**PLANNED UNIT DEVELOPMENT
& SUBDIVISION STAFF REPORT****Date: September 6, 2012****DEVELOPMENT NAME**

Pinebrook Subdivision

Planned Unit Development Approval to amend a
previously approved Planned Unit Development to allow shared access and parking between
multiple building sites, and Subdivision approval to create 5 lots.

SITE PLAN

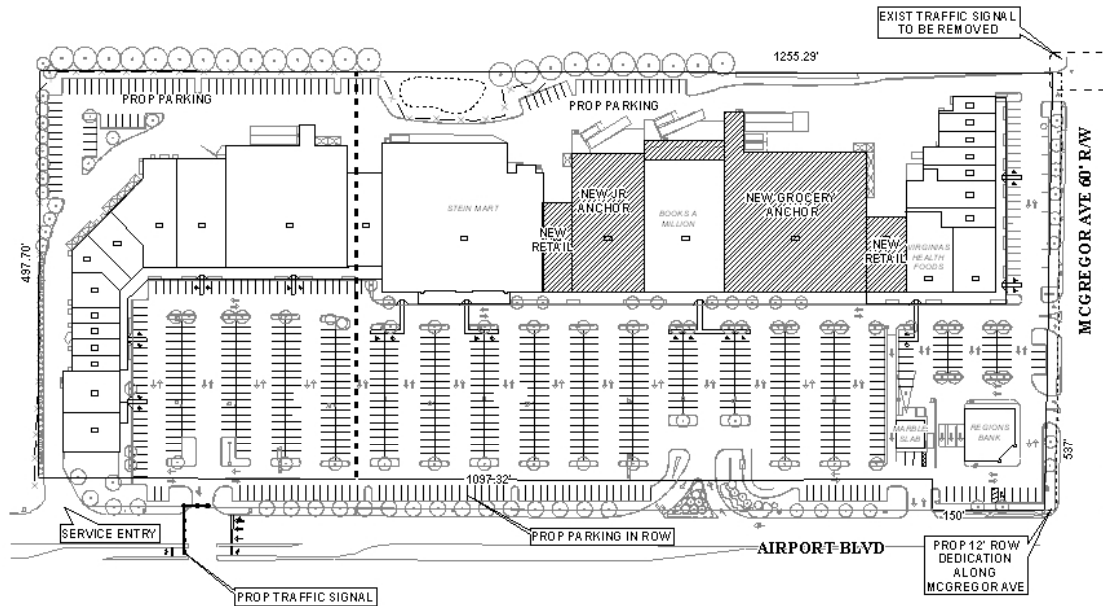
Since dedication along South McGregor Avenue will be required, the subdivision plat and the PUD site plan should be revised to reflect and accommodate the dedication. It should be pointed out that parking and signage fronting South McGregor Avenue will be impacted by the dedication of right-of-way. Furthermore, the dedication may impact on-site circulation.

The site plan submitted with the PUD application reflects some but not all of the improvements recommended by the TIS, thus the site plan should be revised to specifically show all proposed changes recommended by the TIS or by Traffic Engineering.

The site plan does not accurately reflect the current tenant mix and uses. Tenants are depicted that are no longer present, and other tenants are depicted in locations that are different from their actual location in the development. The site plan should be revised to accurately reflect tenant locations, and to quantify in square feet the uses – retail, restaurant, office, etc. As the site plan tenant mix is not accurate, staff cannot verify adequate parking on the site. Furthermore, as a new tenant is involved, and as no information as the type of parking ratio required for the new

tenant is provided, staff cannot determine if parking on site will be adequate. It should also be pointed out that there appear to be several parking spaces located in the service road right-of-way near the Marble Slab Creamery: parking in the right-of-way cannot count towards required parking.

The site plan also depicts a proposed entry just west of the proposed new traffic signal. Parking spaces depicted behind Write Impression are angled, and the drive width narrows down to about 15 feet: the entry from Airport Boulevard should be signed as “one way” from Airport into the development. Also it appears that parking spaces in the Northwest corner of the site are so arranged to provide inadequate/substandard circulation and maneuvering. The International Fire Code may require a minimum 20-foot wide fire lane around the rear of the building, with the lane 26-feet in width where-ever there is a fire hydrant.

The drive-through for the Marble Slab Creamery is not marked and does not include one-way arrows. The site plan should be revised to include appropriate markings and labels.

Dumpster pads are depicted on the site plan, but aerials and a staff visit to the site verify that there are multiple dumpsters on the site that are not depicted on the submitted site plan, and which would impede implementation of the parking scheme as proposed. The site plan should be revised to show all existing or anticipated dumpsters.

Regarding trees and landscaping, Urban Forestry has requested that the site fully comply with the requirements of the Zoning Ordinance. No information is provided on the site plan regarding total landscape area, frontage landscape area, or trees. The site plan should be revised to reflect compliance with the tree and landscaping requirements of the Zoning Ordinance.

Typically sidewalks are required as part of commercial subdivision applications. A sidewalk waiver was approved for that portion of the Regions Bank site fronting onto South McGregor Avenue, but not along Airport Boulevard. The site plan should be revised to show existing sidewalks, and should either show new sidewalks along the remaining frontages where sidewalks have not been waived, or sidewalk waiver applications should be submitted. Also, a pedestrian crossing should be provided at the proposed signalized intersection, complete with accessible crosswalks.

The site plan depicts various other revisions, including the conversion of the service road area along Airport Boulevard to parking and landscape area for the shopping center, new dumpsters and dumpster pads, revised parking, and a revised right in, right out entry on McGregor Avenue.

Use of the existing Airport Boulevard service road for parking is proposed. The service road was required as part of a 1968 rezoning of a large portion of the site from R-A, Residential-Agricultural, to B-2. The conversion of the existing service road area to 71 parking spaces for the shopping center will require either the vacation of the right-of-way or the execution of a right-of-way use agreement via the City Council. A vacation of the right-of-way is the preferred route for the City, as it will provide free-and-clear ownership to the applicant if the request is approved. As submitted, the development will have 716 parking spaces on the property and 71 proposed in the Airport Boulevard service road right-of-way, for a total of 787 parking spaces.

It should be pointed out that the Subdivision Regulations require the provision of a sidewalk along all street frontages, and one of the requested revisions was the depiction of sidewalks. No new sidewalks are depicted on the revised site plan, however, a note appears on the plan stating that a sidewalk waiver will be requested in a separate application to the Planning Commission. A sidewalk waiver was approved by the Planning Commission in May 2009 for that portion of the Regions Bank site fronting onto McGregor, but was denied for that portion fronting Airport Boulevard.

The main buildings of the shopping center will be served by a service driveway behind the main building, with a dedicated entrance from Airport Boulevard. Due to the narrow widths along portions of the service drive, it is recommended that the drive be signed and marked as one-way in from Airport Boulevard, and requiring all traffic to exit at the Northeast side of the property where the service drive returns to the main parking and circulation area. The Northeast service drive should be marked with "do not enter" signs and marked with arrows indicating that it is one way.

- 1) Revision of the site plan to depict dedication along the entire frontage of South McGregor Avenue to provide 50-feet from centerline;
- 2) Revision of the site plan to depict any new building footprint that may be proposed to accommodate the prospective tenant for the site;

- 3) Revision of the site plan to reflect compliance with the Traffic Impact Study recommendations and Traffic Engineering comments (*The right-of-way width on McGregor Avenue is not illustrated the same on the Subdivision plan versus the PUD plan. Right-of-way dedication should be consistent across the property frontage, in accordance with the Master Street Plan. A revised traffic impact study was submitted for this development. Traffic Engineering approval of this site is contingent upon the construction by the developer/owner of all improvements identified in the study. It should be noted that the improvements include the installation of a traffic signal near the western property limits on Airport Boulevard and the removal of the traffic signal near the northern property limits on McGregor Avenue. Although it is not clearly stated, the*

- 5) Revision of the site plan to accurately depict the tenant location and mix, and to accurately provide tenant space sizes in square feet;
- 6) Revision of the site plan to show all existing dumpsters and dumpster pads;

- 7) Revision of the site plan to depict a compliant and realistic parking and truck/vehicle circulation scheme, showing any required one-way circulations, even if the scheme will result in a reduction in the total number of parking spaces below what meets typically required parking ratios by use;

- 9) Revision of the site plan to label any existing drive-throughs and one-way aisles;
- 10) Compliance with Urban Forestry comments (*Property to be developed in compliance with state and local laws that pertain to tree preservation and protection on both city and private properties (State Act 61-929 and City Code Chapters 57 and 64). Full compliance with landscaping and tree requirements of the Zoning Ordinance.);*

- 11) Revision of the site plan to depict existing sidewalks, and new sidewalks along all other road frontages where they have not been waived by the Planning Commission;

- 12) Revision of the site plan to depict an accessible pedestrian crossing at the proposed signalized intersection; and

- 13) Revision of the site plan to provide tree and landscape area information to depict full compliance with the tree and landscaping requirements of the Zoning Ordinance.

- 8) *Vacation of the Airport Boulevard service road right-of-way prior to the recording of the final plat;*
- 9) *The marking and signing of the service drive to be one-way in from Airport Boulevard and one-way out (with "do not enter" signs) where the service drive rejoins the parking and circulation at the Northeast portion of the site;*
